Proposal for an amendment to GTR No. 3 (Motorcycle Brake Systems)

Submitted by the expert from International Motorcycles Manufacturers Association

The text reproduced below was prepared by the expert from IMMA in order to introduce amendments to clarify the text and introduce simplified test procedures in this regulation and align it with UNECE Regulation No. 78. The modifications to the current text of the Regulation are marked in bold or strikethrough characters.

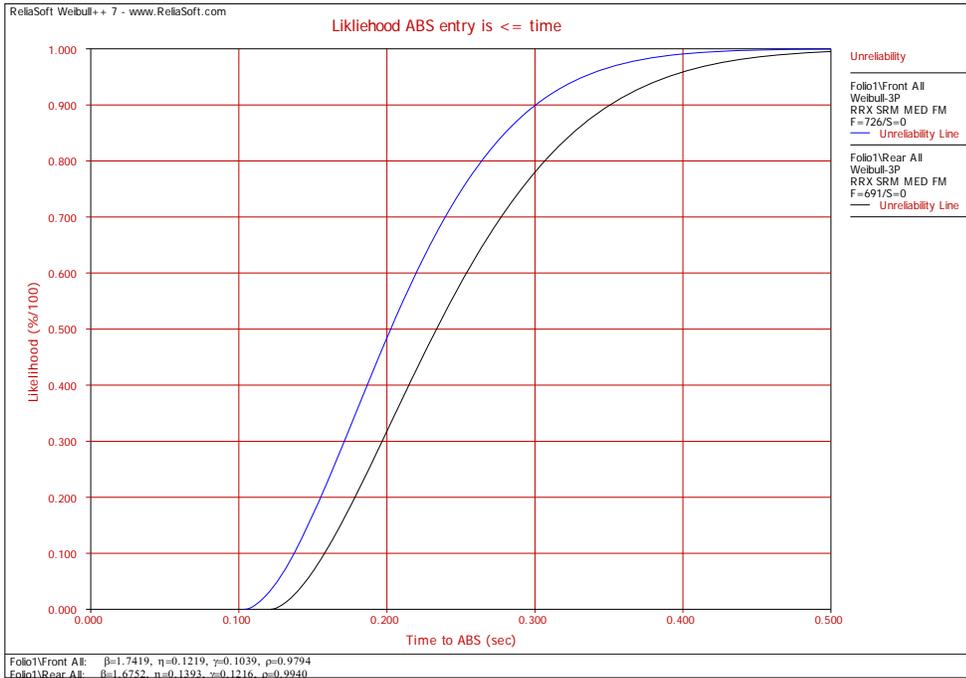
“The force applied is that which is necessary to ensure that the ABS will ~~eyele~~ **fully be fully cycling** throughout each stop, down to 10 km/h.”
- 11) This amendment aligns R78 and GTR 3 with respect to the simple test method and also updates the use of SI units and change in decimal points.
- 12) It has been noticed in testing that the brake application rate specified in section 4.9.5.1 can result in a large number of test failures. If can be seen in the chart below that the 0.2 second lower limit shows a failure rate is between 30% and 50% of the time.

By reducing the lower limit to 0.1 seconds the test failure rate reduces to practically zero. Allowing the reduction tends to make the regulation more stringent by including a greater number of brake force application rates and eliminates restrictive test requirements.

- (f) Brake application rate:
The brake control actuation force is applied in **0.1 – 0.5** seconds.
- 4.9.6. Wheel lock check - high to low friction surface transition
